UNITED STATES PATENT AND TRADEMARK OFFICE

| APPLICATION NO. | FILING DATE | FIRST NAMED INVENTOR | ATTORNEY DOCKET NO. | CONFIRMATION NO. |
|-----------------|-------------|----------------------|---------------------|------------------|
| 10/598,821 | 07/10/2007 | Hermann Wetter | 3144/121US | 1701 |

| Office Action Summary | Application No. 10/598,821 | Applicant(s) WETTER, HERMANN | |

DETAILED ACTION

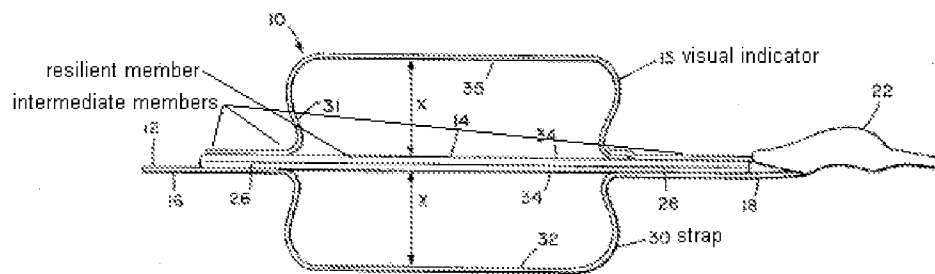
Claims 1, 2, 4-6, 22 and 23 have been rejected under 35 U.S.C. 102(b) as being anticipated by Allen, 5738259. Allen discloses the claimed invention as shown in the annotated drawing.

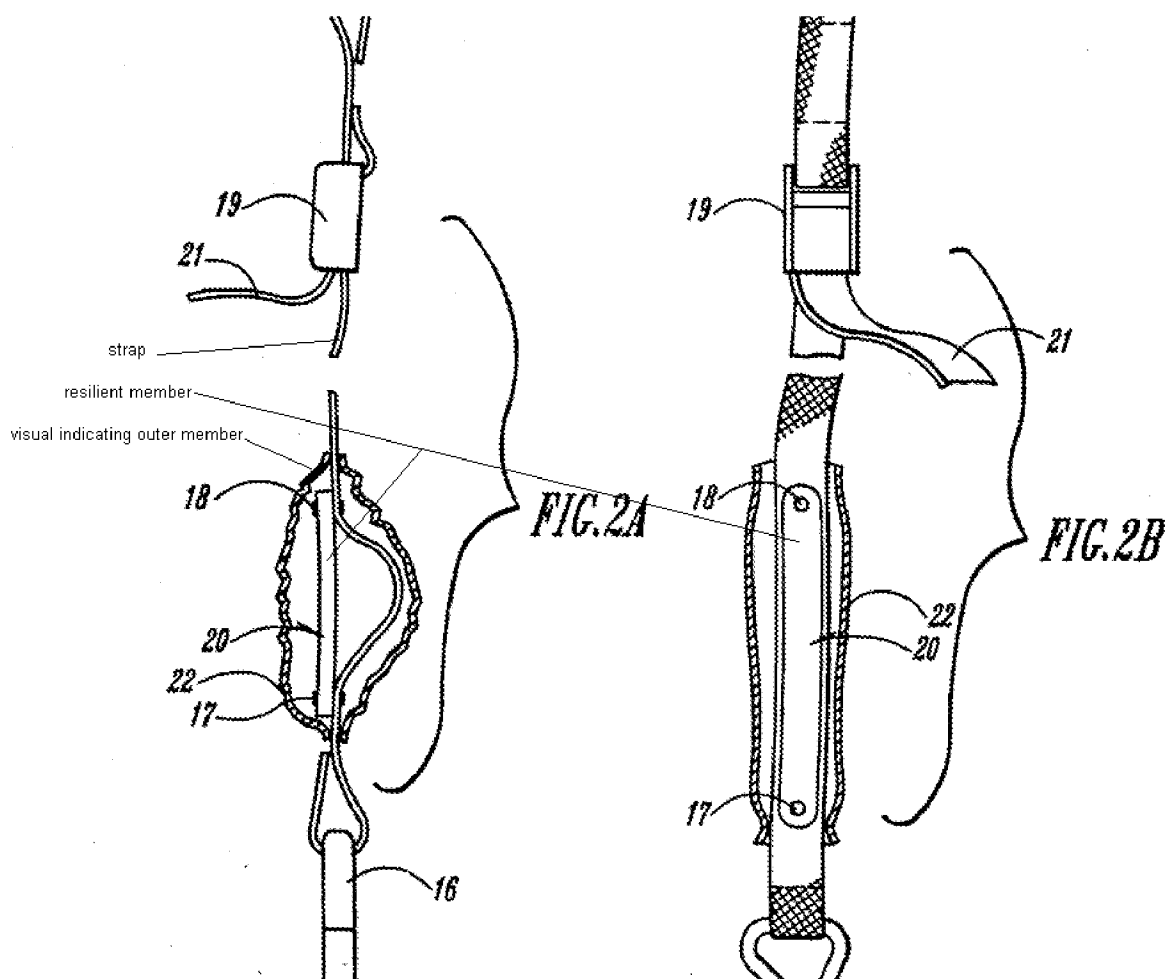
Claims 1 and 7 have been rejected under 35 U.S.C. 102(b) as being anticipated by Dalen, 5402557. Dalen discloses the claimed invention as shown in the annotated drawing.
